Addendum No. 1

East Pearl Street Parking Lot Improvements

For City of Jerseyville
Jersey County, Illinois

H&A File No. 140-337
March 11, 2021

PATH=c:\users\j\documents\00140 - jerseyville, city\337 - downtown parking lot\cad\dwg\city\jerseyville parking lot.dwg
PLOTED: 3/11/2021 8:54:03 PM BY: lott, adam

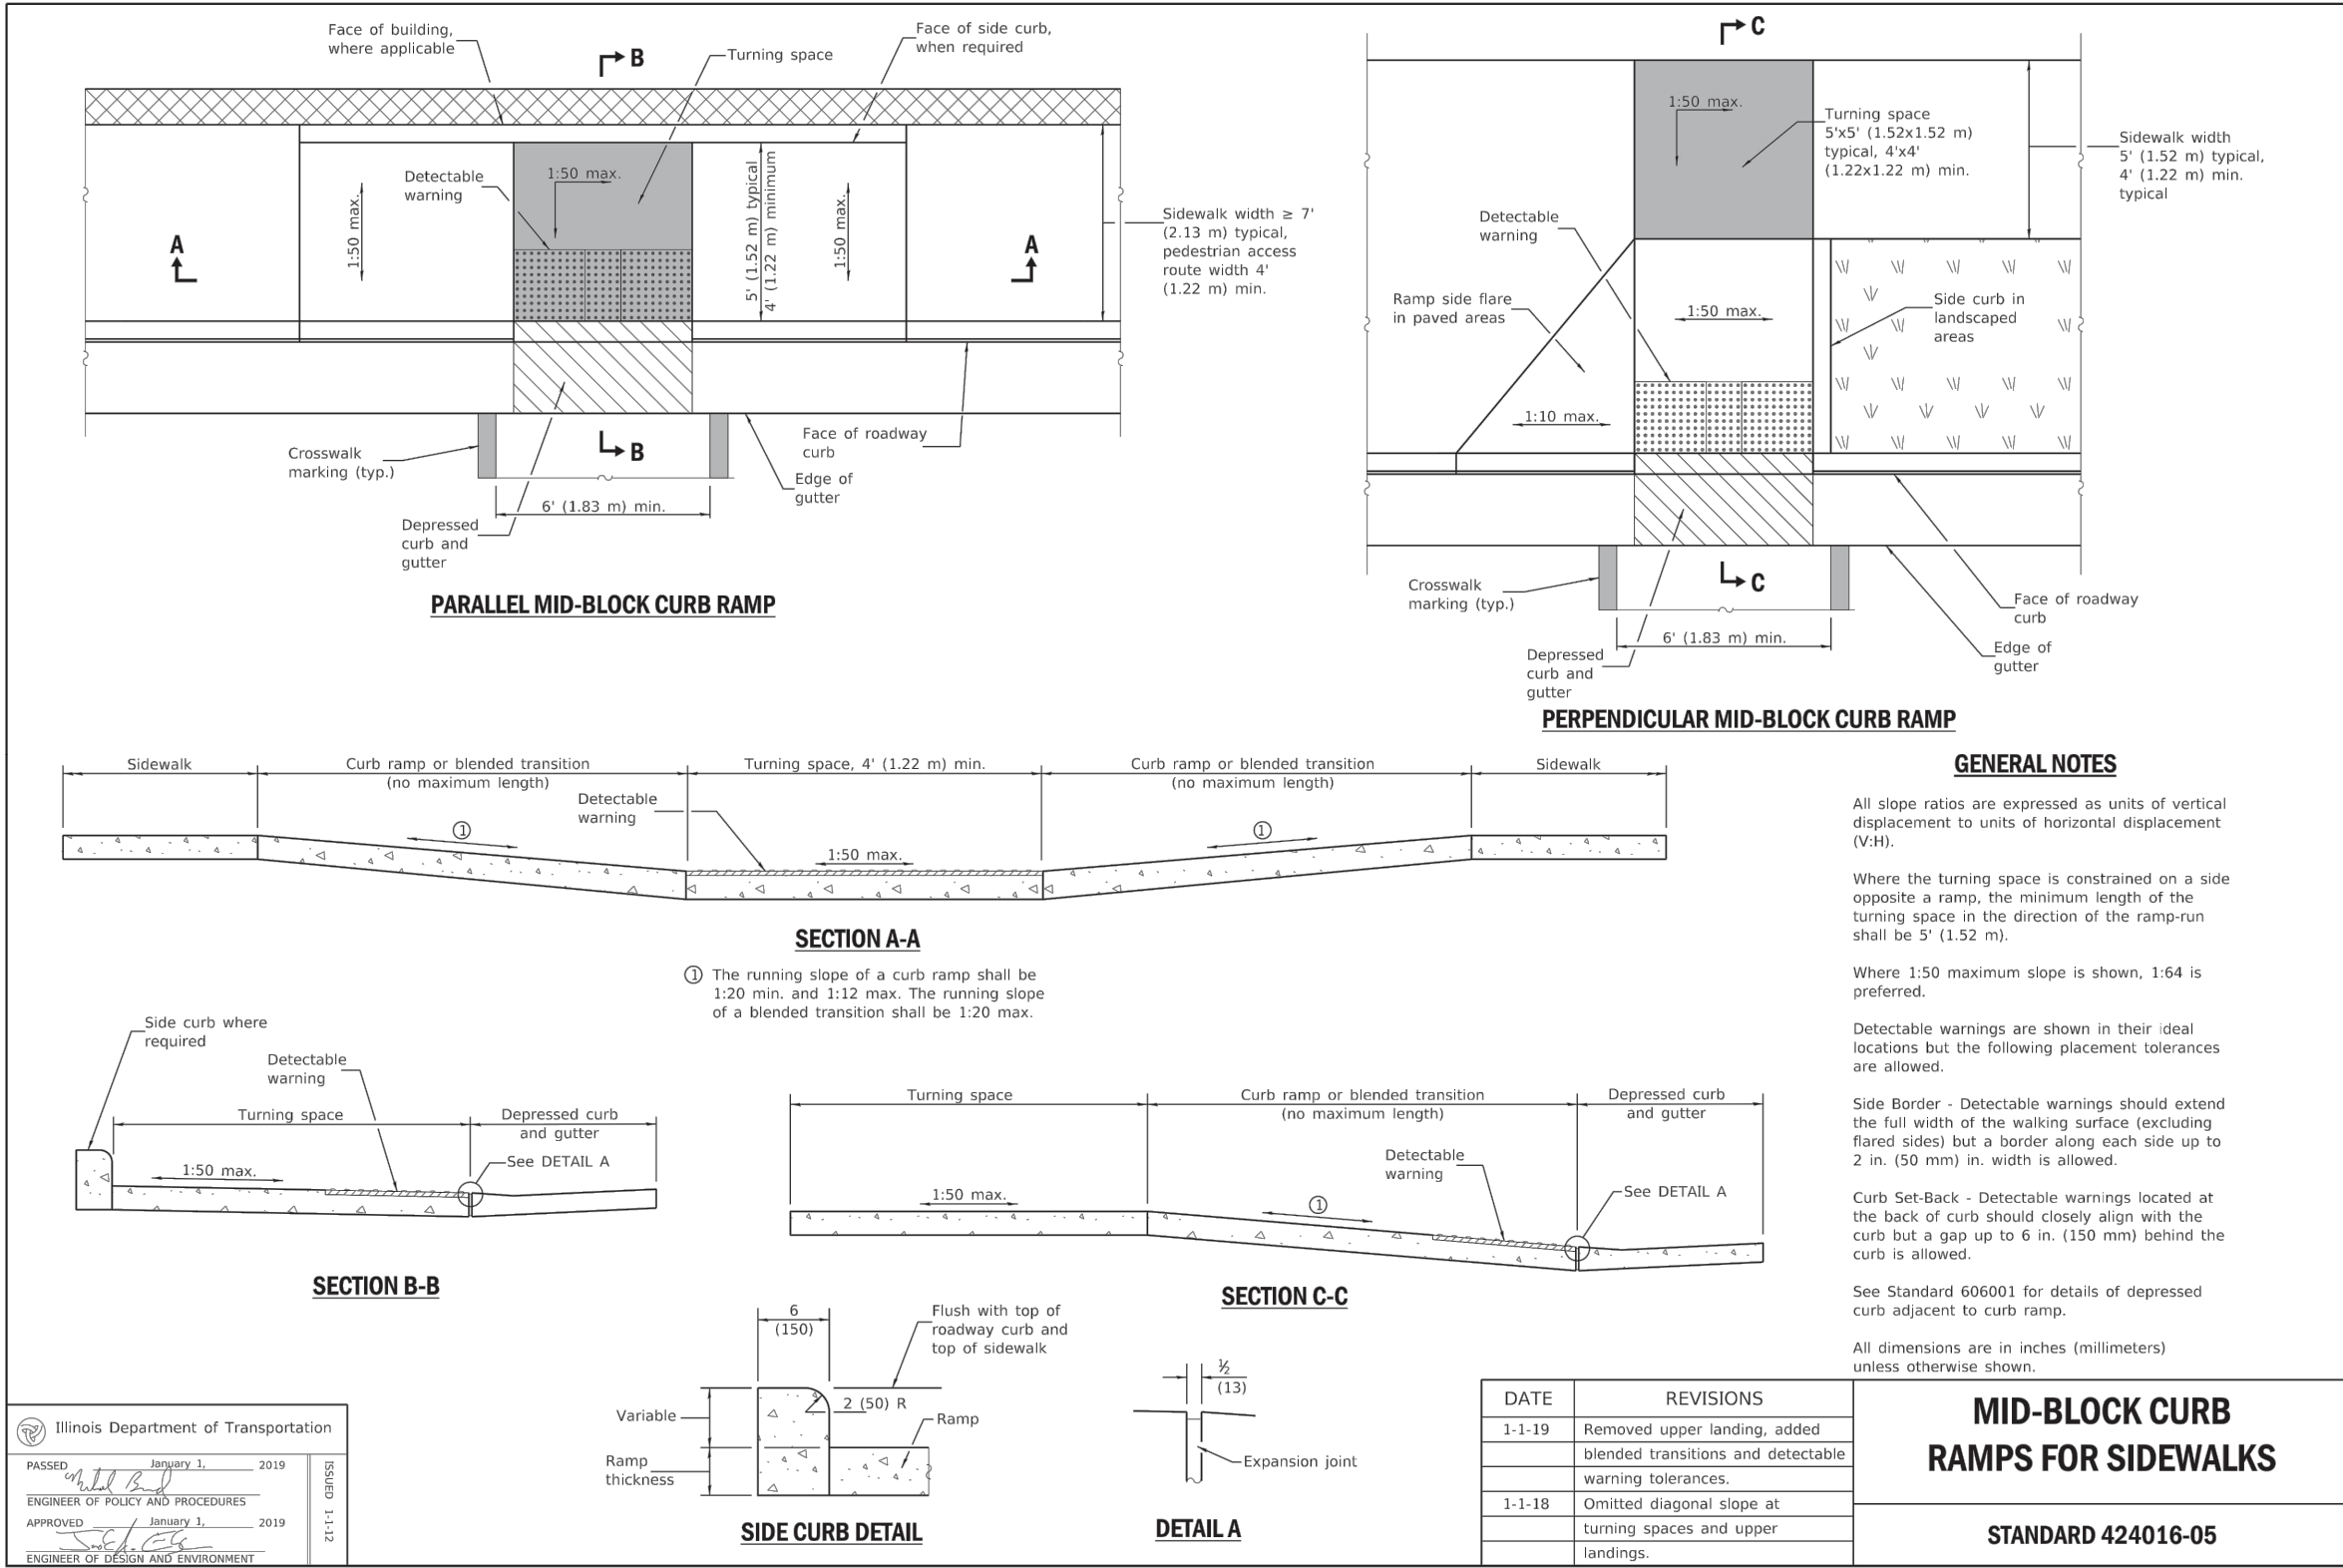
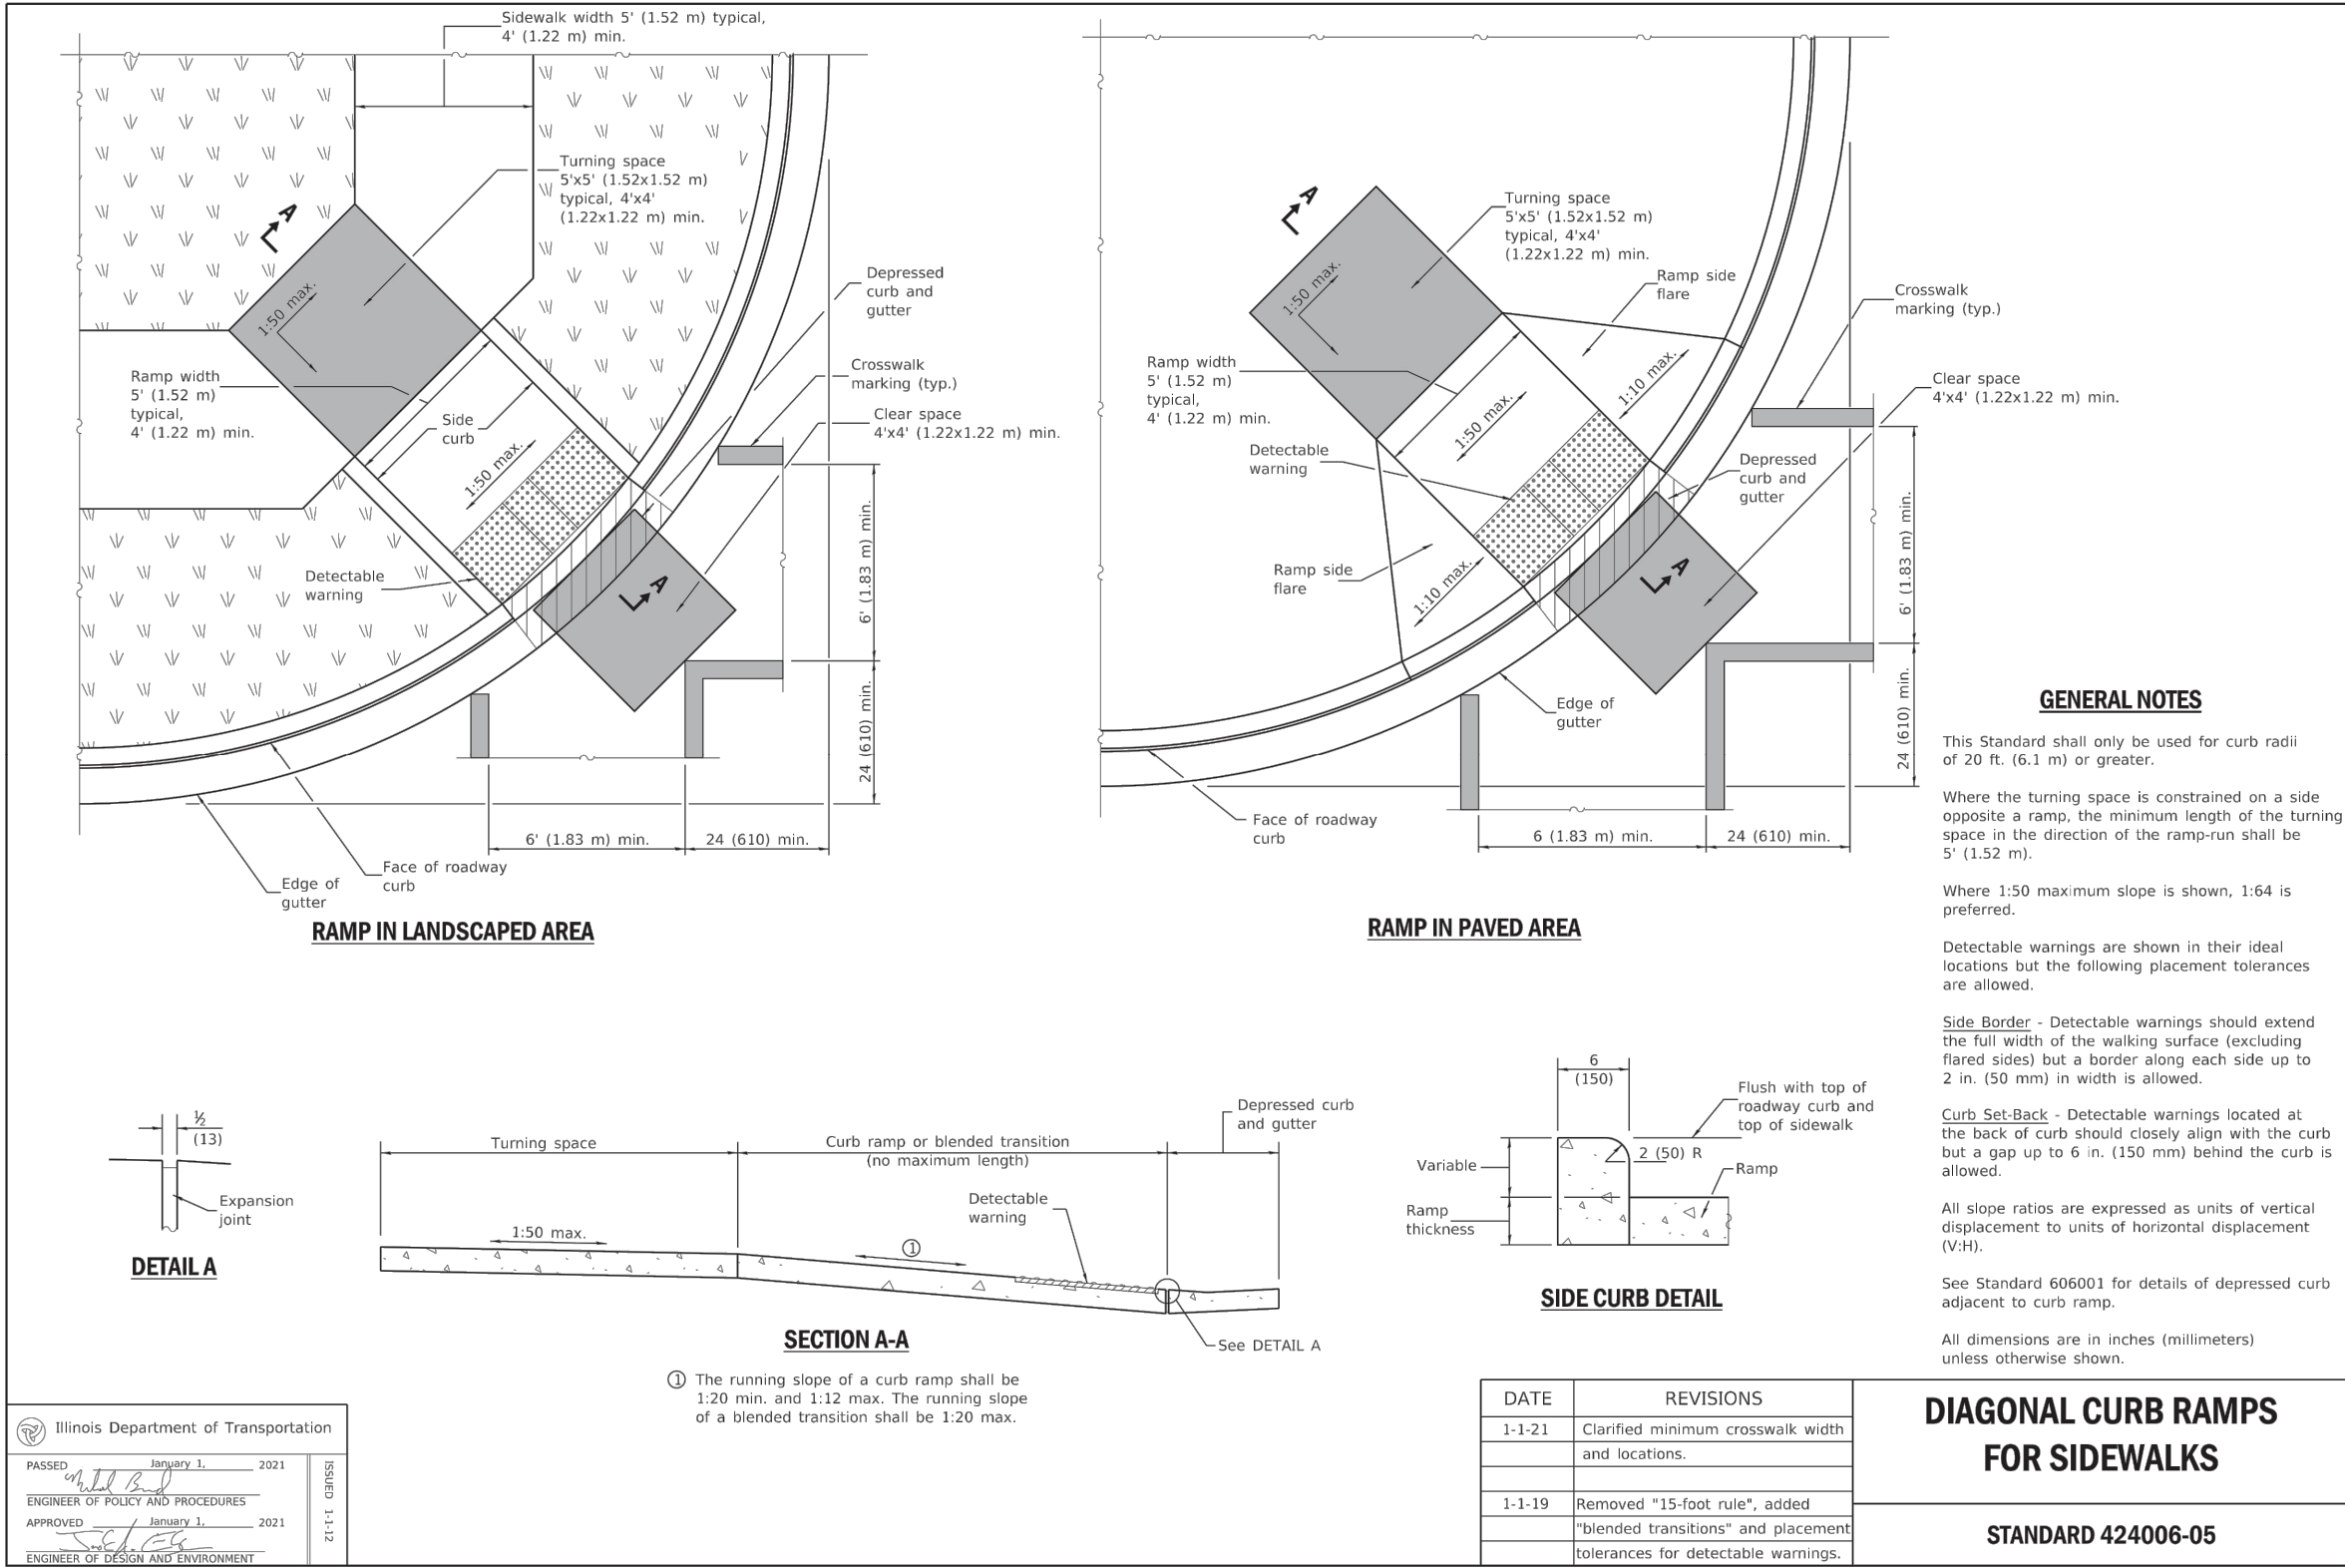
Sheet 9: Added details for dumpster enclosure and drainage trench with cover
